dsPIC30F6011/6012/6013/6014

dsPIC30F6011/6012/6013/6014 Family Silicon Errata and Data Sheet Clarification

The dsPIC30F6011/6012/6013/6014 family devices that you have received conform functionally to the current Device Data Sheet (DS70117F), except for the anomalies described in this document.

FIGURE 1: DCI SLAVE WORK AROUND

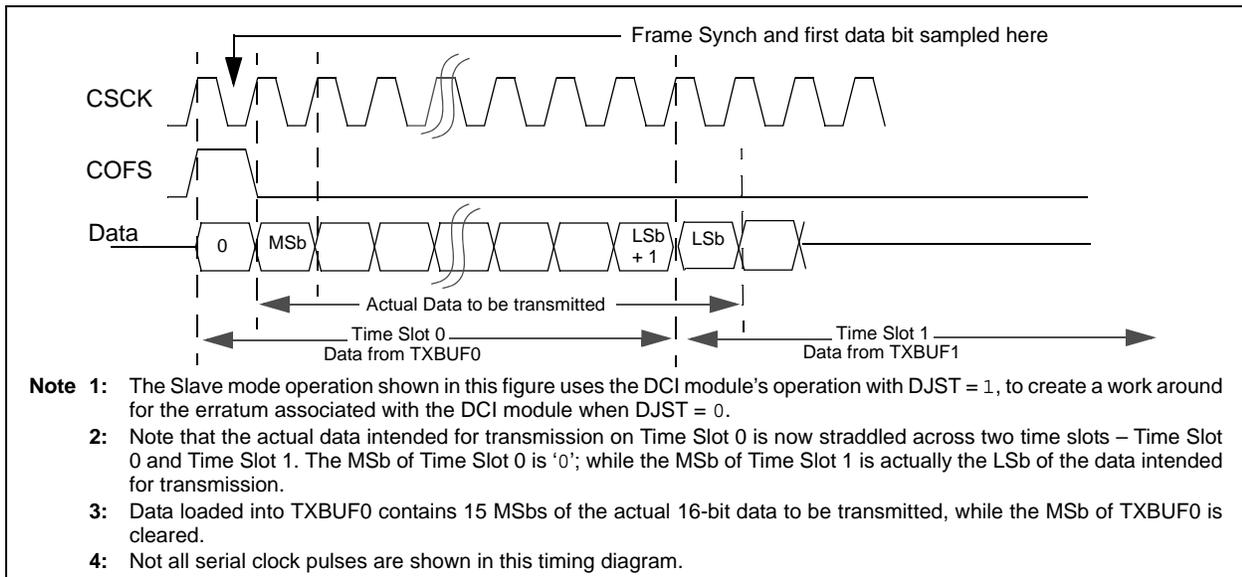
The Data Converter Interface (DCI) module does not function correctly in Slave mode when the following conditions are true:

- The DCI module is configured to transmit/receive one serial clock (bit clock) after the frame synchronization pulse, DJST (DCICON1<5>) = 0.
- The frame length chosen is longer than 1 word, COFSG<3:0> (DCICON2<8:5>) > '0000'.

1. Set the DJST bit to '1'.
2. Enable an additional time slot immediately following each time slot intended for communication.
3. Enable an additional transmit/receive buffer word (modify COFSG bits) or an additional bit per word (modify WS) for each time slot intended for communication.
4. Shift the data word by 1-bit to the right and load the transmit buffer word(s), such that the Least Significant bit of the original data word to be transmitted is loaded into the additionally enabled bit of the Transmit Buffer register, TXBUF_n, or the Most Significant bit (MSb) of the additionally enabled transmit buffer, TXBUF_n + 1.

Assume, the application needs the DCI module to act as a Slave transmitting 1 serial clock after the frame synchronization pulse is received. Further, assume that the application needs to transmit 16-bit data word on Time Slot 0 and the communication is over a 256*Fs channel. In order to reduce interrupt frequency, we enable all 4 transmit buffers. The DCI module SFRs should be initialized as follows before being enabled:

- DCICON1 = 0x0720, DCICON2 = 0x0DEF
DCICON3 = 0x0000,
TSCON = RSCON = 0x0003

An example of loading the DCI transmit buffers for the configuration above is shown in Example 11. A timing diagram in Figure 1 illustrates the various signals for this example. A similar rule may be applied to reading the received data from the RXBUF_n SFRs.
